INQUIRY INTO IMPACT OF THE WESTERN HARBOUR TUNNEL AND BEACHES LINK

Organisation: Willoughby City Council

**RE: INQUIRY INTO THE IMPACT OF THE WESTERN HARBOUR TUNNEL AND BEACHES LINK –
WILLOUGHBY CITY COUNCIL SUBMISSION**

Figure 2: Proposed reconfiguration of the Freeway between Sydney Harbour Bridge and Sydney Harbour Tunnel and Gore Hill Freeway (Source: EIS Chapter 5 Project Description page 5-36)

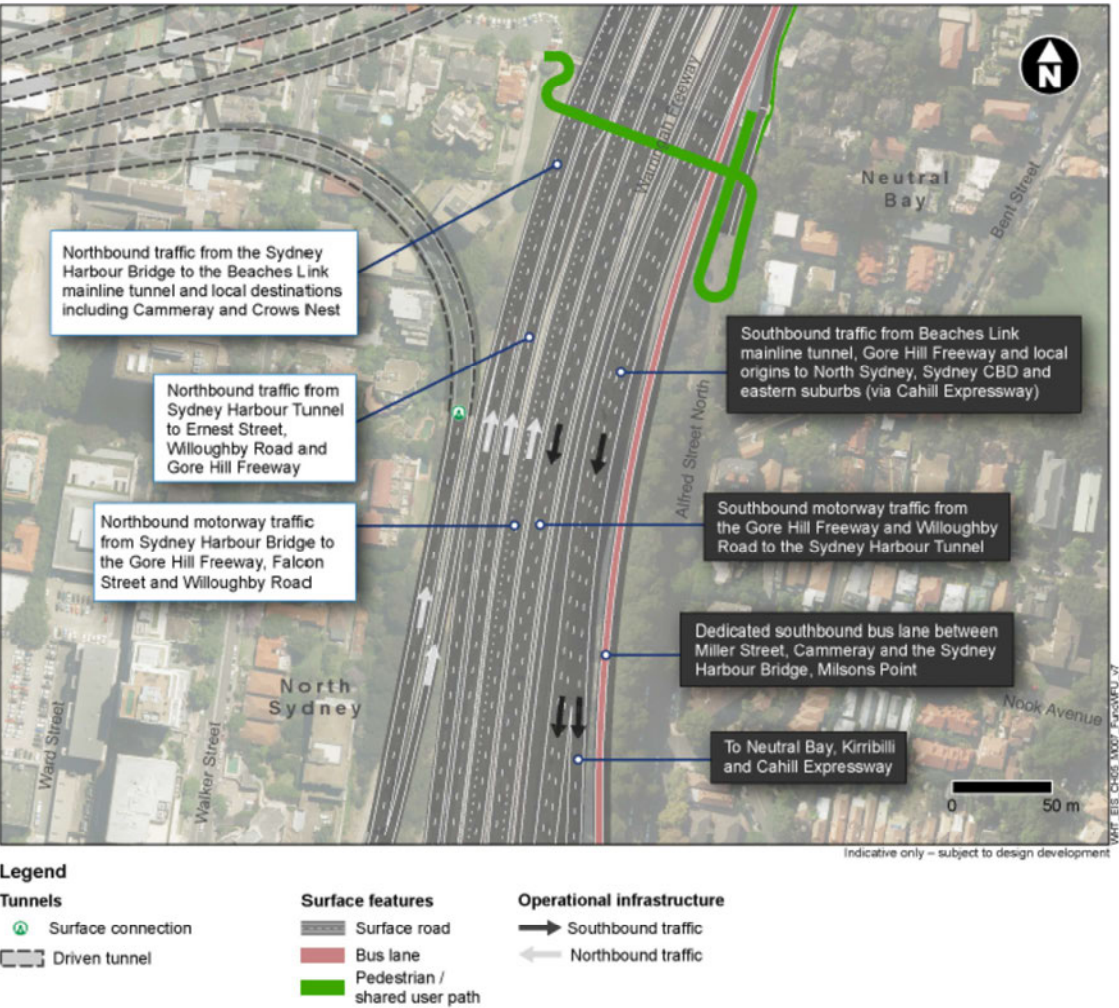
A diagram showing the proposed reconfiguration of the Freeway and impact on access between Sydney Harbour Bridge and Sydney Harbour Tunnel and Gore Hill Freeway is provided in Figure 2 below.

Lane configuration in the vicinity of Miller Street, Cammeray

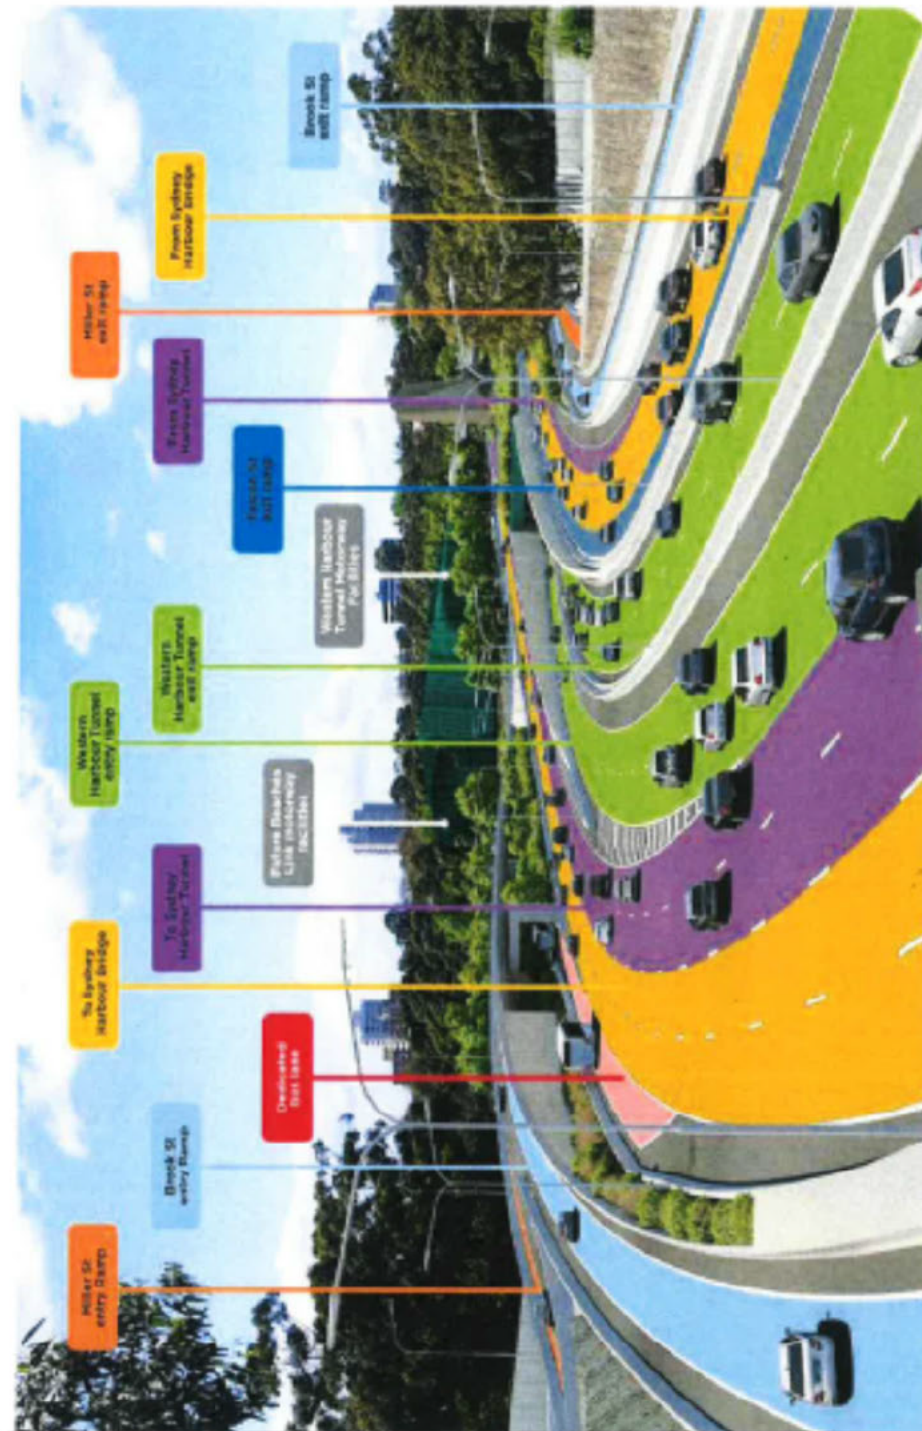
In view of the successful existing traffic configuration, with Sydney Harbour Tunnel traffic having the option of using both Miller and Brook St ramps, it is difficult to appreciate either the reasons for, or the benefits of, the proposed reconfiguration and we request that this aspect of the planning be abandoned in favour of the existing ramp entries and exits. To shift a major portion of the Sydney Harbour Tunnel traffic onto Willoughby Rd will further overload an arterial road already acknowledged as operating at full capacity in peak hours.
